TRANS/WP.29/GRSP/2001/15/Rev.2/Corr.1
17 March 2003

PROPOSAL FOR DRAFT CORRIGENDUM TO REGULATION No. 15
(Safety-belts)

Revision 2 - Corrigendum 1

Transmitted by the Expert from European Manufactures of Automotive Suppliers (CLEPA)

Figure 1 – ISO/F3 envelope dimensions for a full-height forward-facing toddler CRS (height 720 mm) - ISOFIX SIZE CLASS A

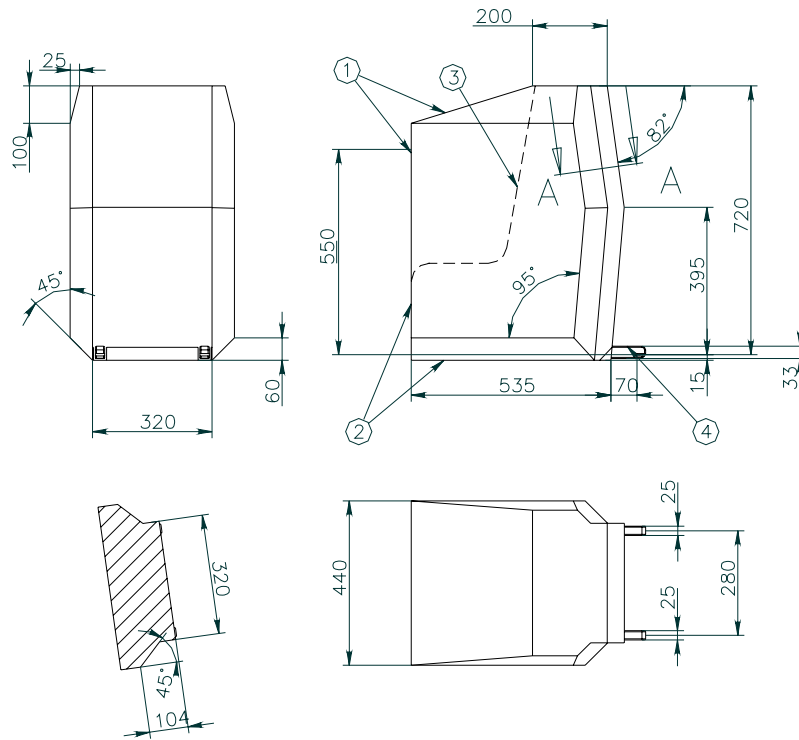
Paragraphs 4.1 and 4.2., amend to read:

“4.1 . Full-height forward-facing toddler child restraint systems envelope.

Figure 2 – ISO/F2 envelope dimensions for a reduced-height forward-facing toddler CRS, (height 650 mm) – ISOFIX SIZE CLASS B”

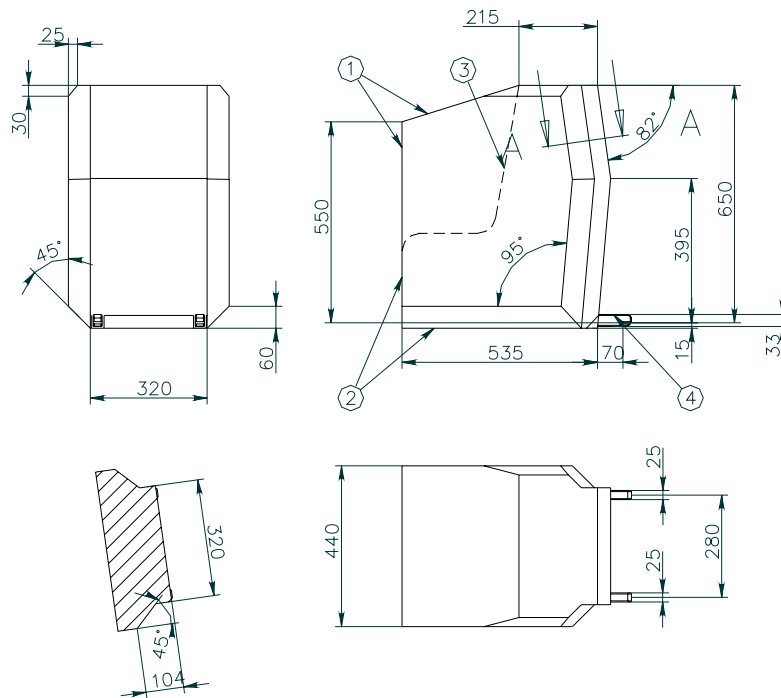
4.2. Reduced-height forward-facing toddler child restraint systems envelope.

Figure 3 – ISO/ envelope dimensions for a reduced-height second version back surface shape forward-facing toddler CRS, (height 650 mm) – ISOFIX SIZE CLASS B1”

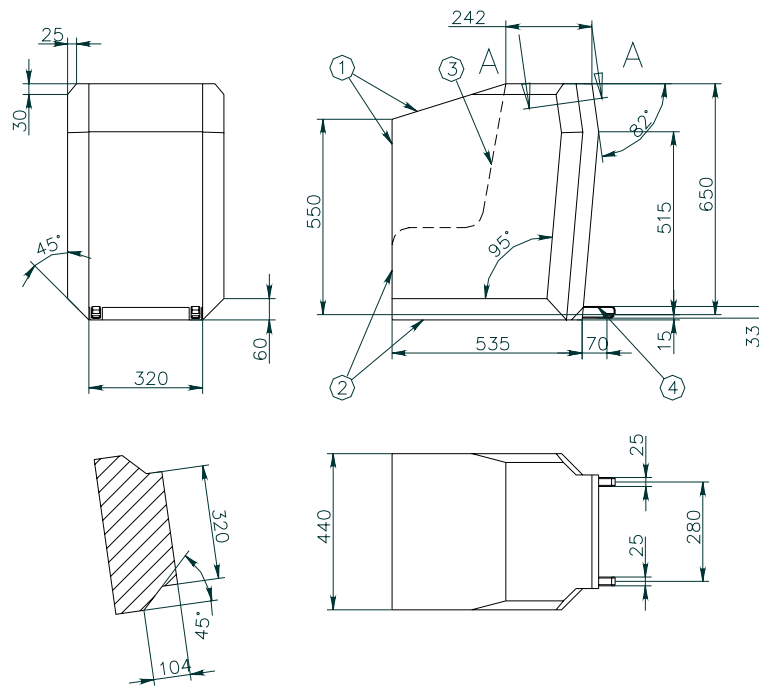
Insert a new paragraph 4.3., to read:

“4.3. Reduced-height second version back shape forward-facing toddler child restraint systems envelope

Figure 4 – ISO/R3 envelope dimensions for a full-size rearward-facing toddler CRS – ISOFIX SIZE CLASS C

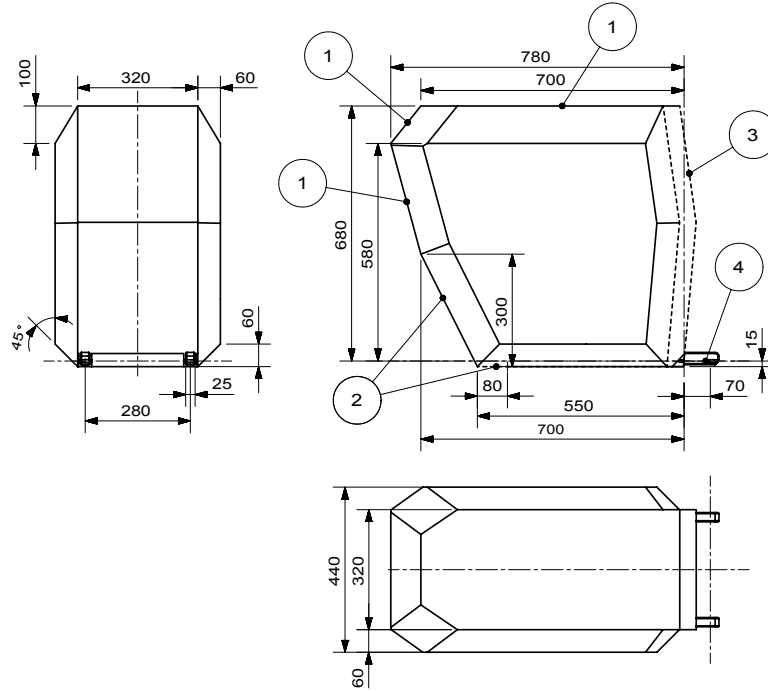
Paragraphs 4.3. to 4.6. (former), renumber as paragraphs 4.4. to 4.7., and amend to read:

“4.4. Full-size rearward facing toddler child restraint system envelope

Figure 5 – ISO/R2 envelope dimensions for a reduced-size rearward-facing toddler CRS – ISOFIX SIZE CLASS D

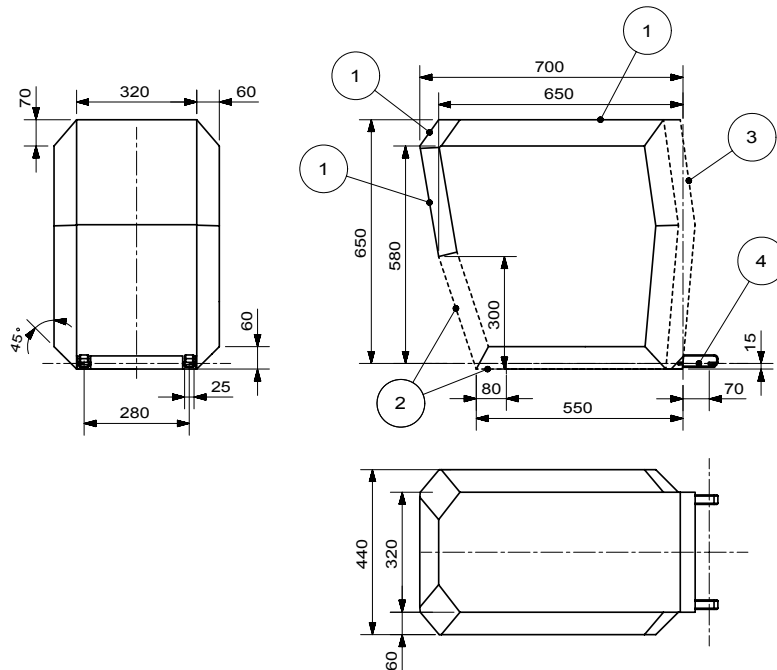
4.5 . Reduced-size rearward-facing toddler child restraint systems envelope

Figure 6 – ISO/R1 envelope dimensions for an infant-size rearward-facing CRS – ISOFIX SIZE CLASS E

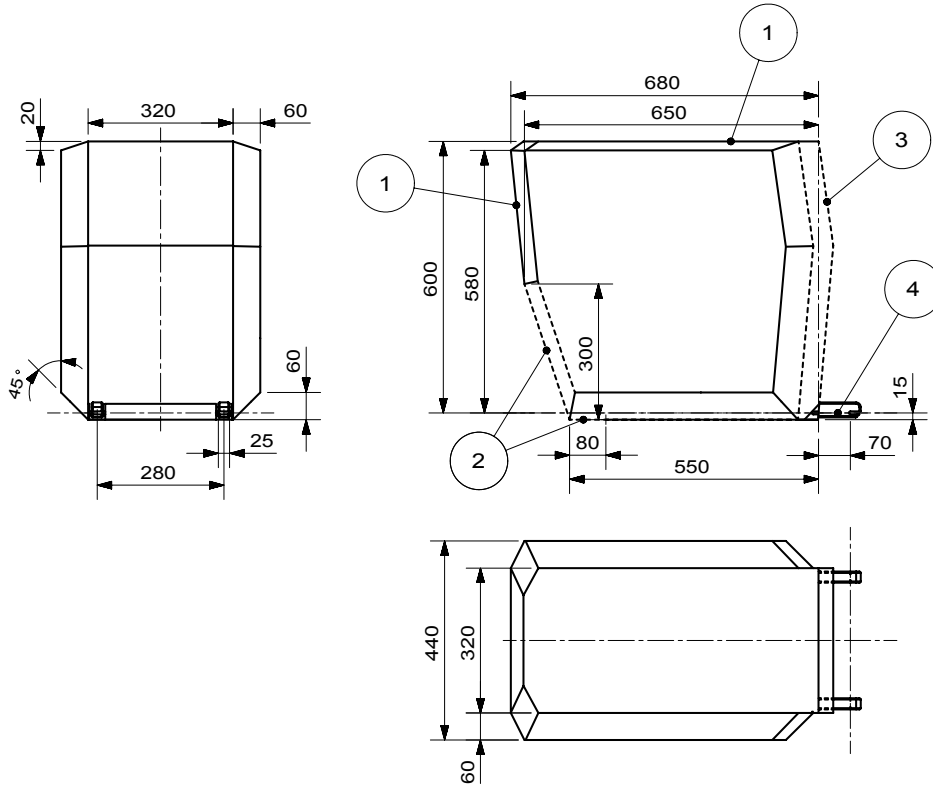
4.6. Rearward facing infant child restraint systems envelope

Figure 3 RF 1 Revised

Figure 7 – Envelop dimensions for lateral facing position CRS - ISO/L1-ISOFIX SIZE CLASS F or symmetrically opposite – ISO/L2 – ISOFIX CLASS G”

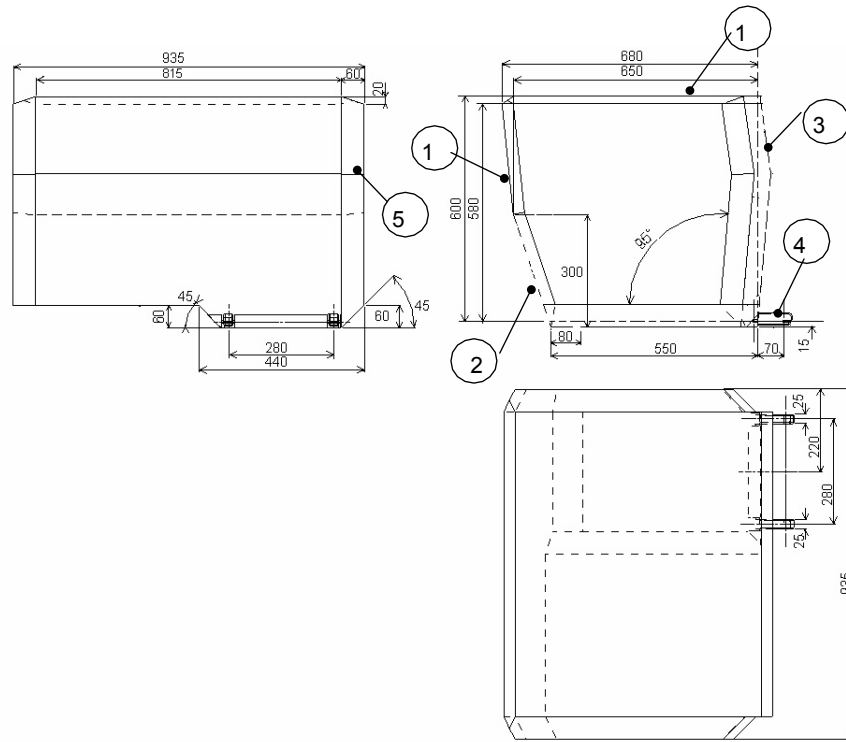
4.7. Lateral facing child restraint systems envelope
